Hawkins Plaza Unit 2

City of El Paso — City Plan Commission — 12/6/2018

<u>SUSU17-00039 — Major Combination</u>

<u>MAJOR ARTERIAL STREET WITH BIKE\HIKE</u>

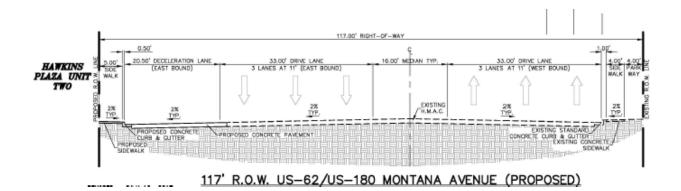
1. To waive the required 10' bike and hike improvements along Montana Avenue.

There are no existing bicycle facilities within ¼ mile of the subject property. The applicant will be installing a 5' sidewalk in lieu of the bike and hike.

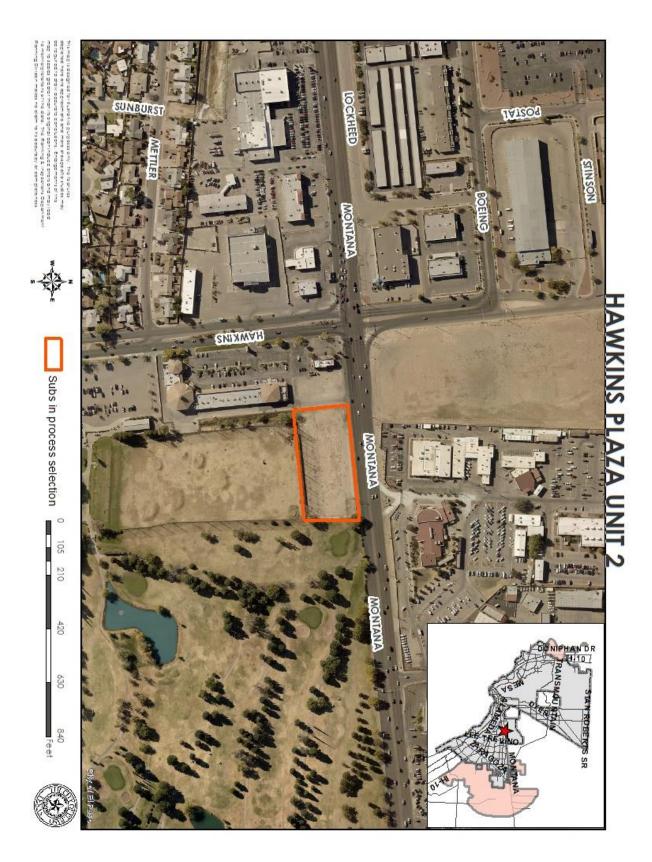
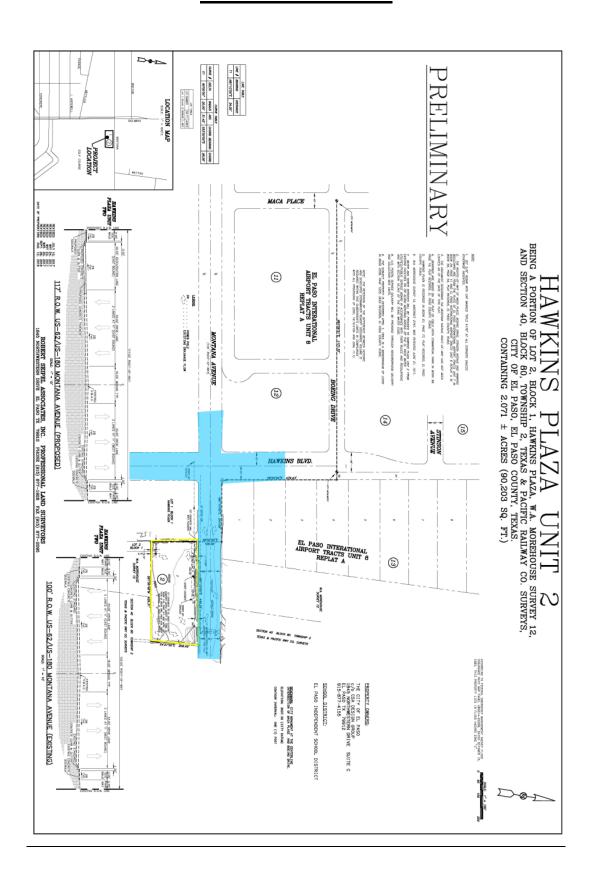
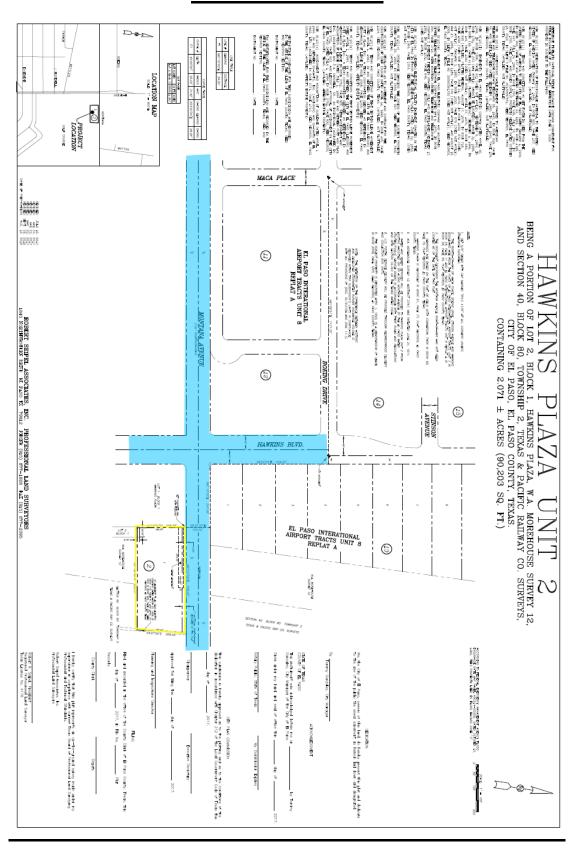
- 1. At the improvement plan stage, provide protection to the subdivision from all offsite stormwater runoff that may have an adverse impact on any improvements.
- 2. Verify if additional ROW line is to follow the new deceleration line curve.

- 1. The Consolidated Review Committee (CRC) reviewed and approved a Preliminary Building Scale Plan at this location on March 28, 2017.
- 2. The cross-section for Montana Avenue should match layout depicted on the approved Preliminary Building Scale Plan.
- 3. A Final Building Scale Plan shall be submitted for review by the CRC prior to the issuance of building permits.

1. Please label 20' sewer easement as 20' PSB easement.
